Origination Form Proposed Revisions to a Standard Plans Index

Originator:	Gibbs, Shae	Index Number:	546-020
Date:	6/18/2024	Sheet Number(s):	2
E-mail:	Shae.Gibbs@dot.state.fl.us	Index Title:	Groud-In Rumble Strips - Arterials and Collectors

GROUND-IN RUMBLE STRIPS -ARTERIALS AND COLLECTORS INDEX

Sheet 2: Deleted Outside Shoulder with Buffered Bike Lane detail

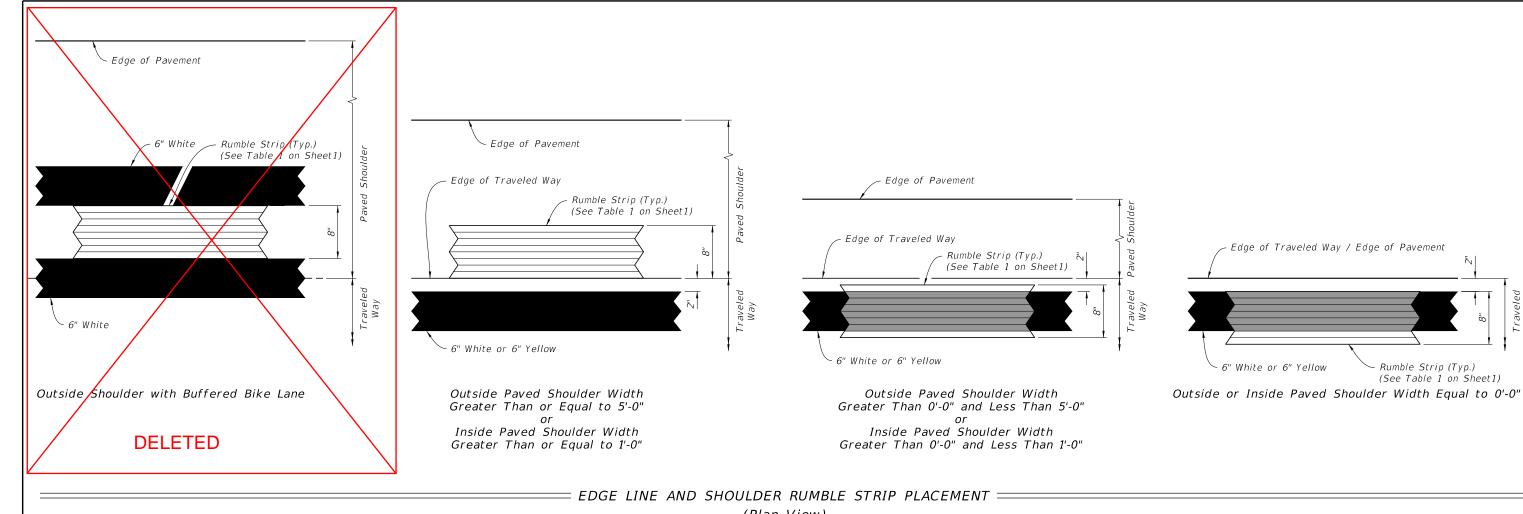
Paved Shoulders are no longer allowed to be marked as Bike Lanes per the new MUTCD 11th edition Section 9E.01
